2.5 Exhaust Divider Plate Modification

MODIFYING 2 BOLT MAIN EXHAUST DIVIDER PLATE TO FIT ON 4 BOLT MAIN BLOCK

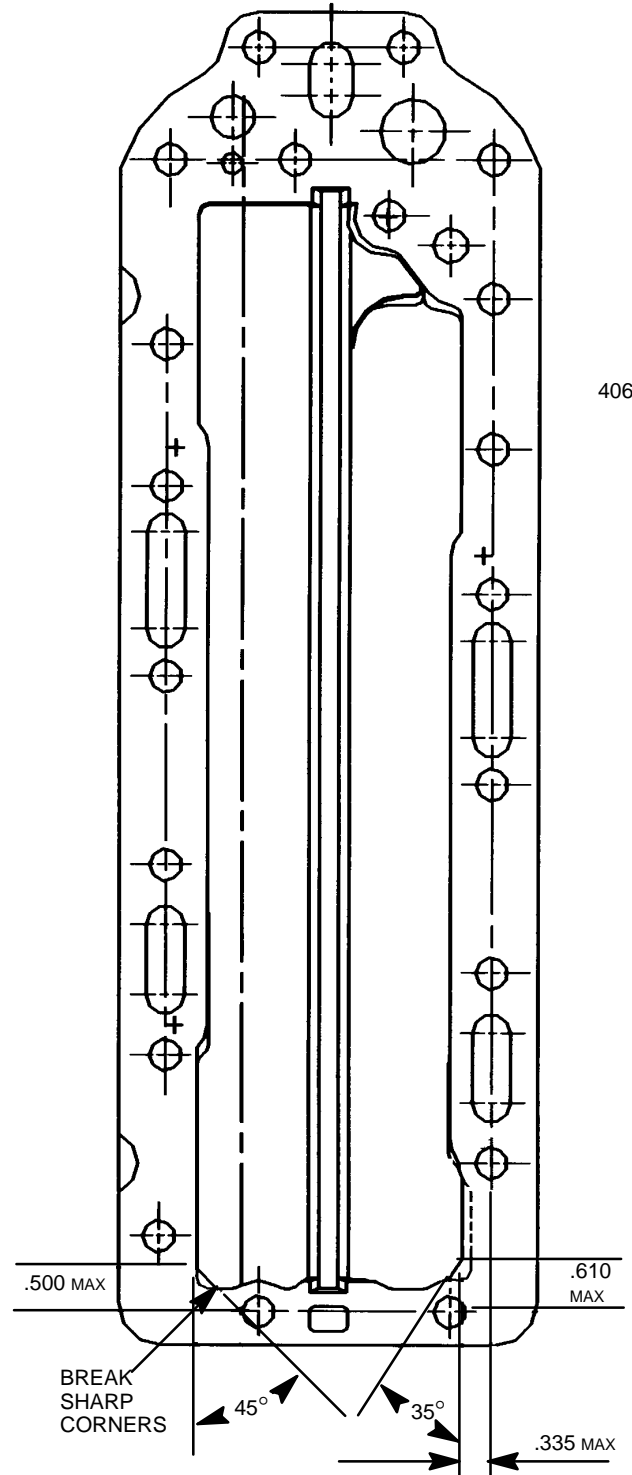
Cylinder block replacement of two bolt main 2.5 engines (S/N OD030202 thru OD030584 & OD110000 thru OD110711) may require either a new exhaust divider plate or a modification to the old plate. The new plate part number is 815552A-1. To modify the existing exhaust plate, file or machine the bottom corners as per illustration or until exhaust fits easily into the block.

a - Grind, File or Machine Material From These Areas
b - Break Sharp Corners In These Areas
